Agenda Item

Application of Rockhaven Homes LLC c/o Battle Law, P.C. to rezone from R-100 (Residential Medium Lot-100) to RSM (Small Lot Residential Mix) Zoning District to allow the construction of single-family detached homes, at 2717 Whitfield Road.

PETITION NO.: Z-22-1245310 (2021-3516)

STAFF ANALYSIS

LINECREST ROAD TRACT

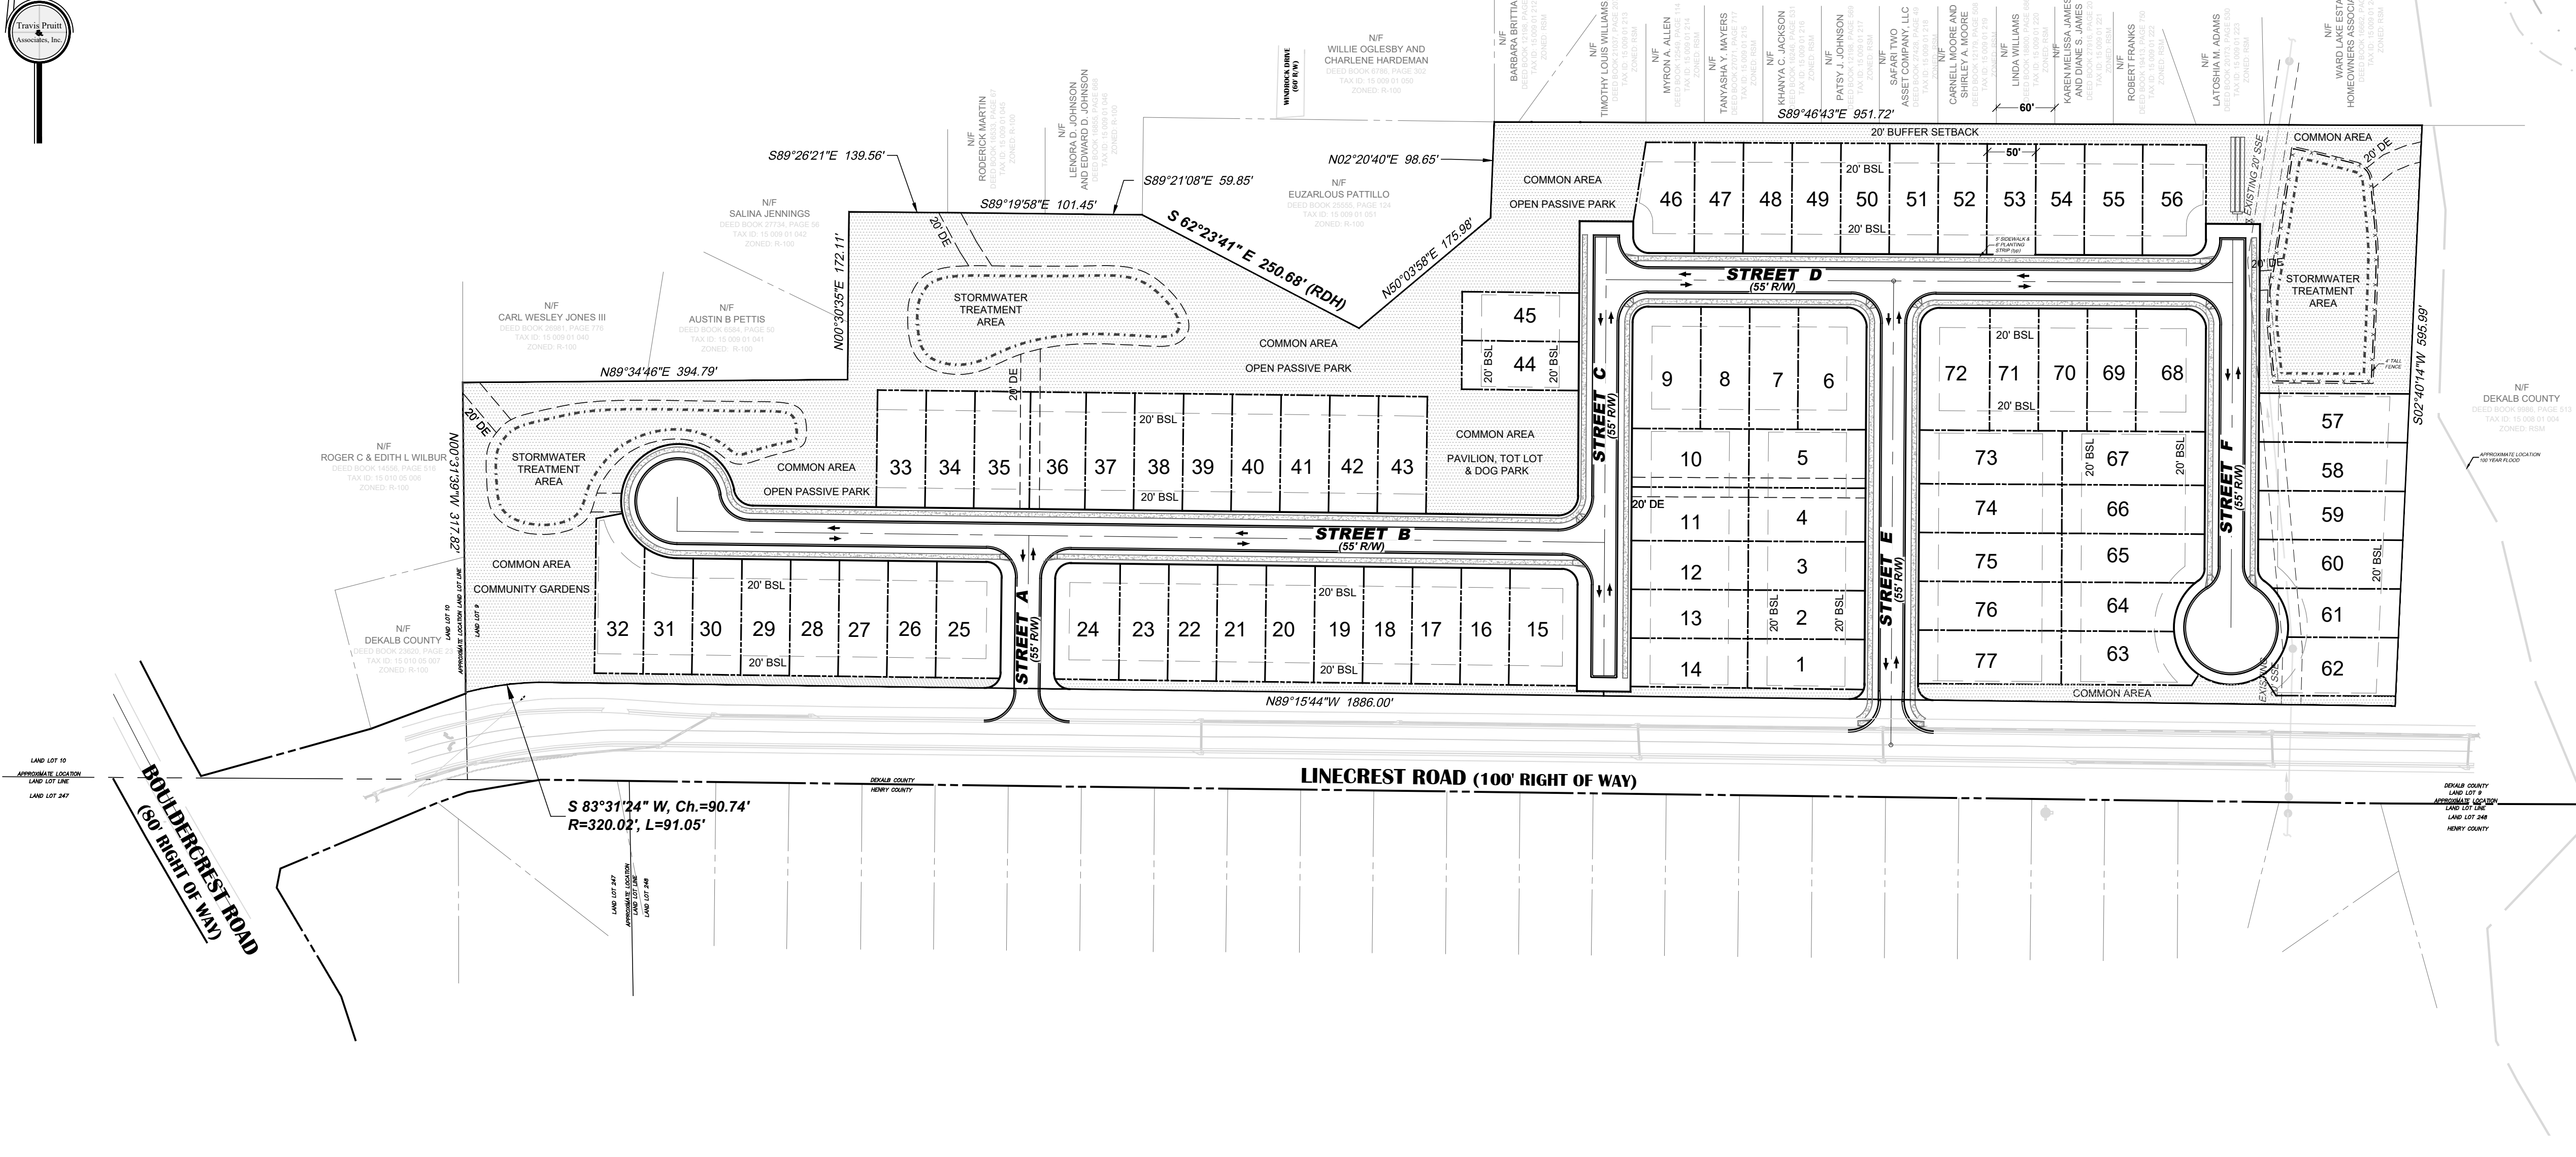
| STREETSCAPE IMPROVEMENTS | 6 ft wide Landscape strip 5 ft wide sidewalk Street trees every 30 feet Street lights every 100 feet | Information not provided. | Undetermined—non-compliance will necessitate variances |

Additionally, looking at the conceptual plan provided, the two proposed detention ponds discharge points are towards existing adjacent properties (based on the drainage easements shown). Concentrated flow cannot be directed towards adjacent properties or leaving the site. An easement will be required through those adjacent properties to convey the discharge to an existing storm sewer structure or to prevent adverse effect on adjacent properties.

1. Maximum of 77 single-family detached lots shall be developed on the property.
2. General compliance with the site plan received by the Planning Department on March 3, 2022 titled "Linecrest Road Tract."
3. A minimum of 20% open space shall be provided.
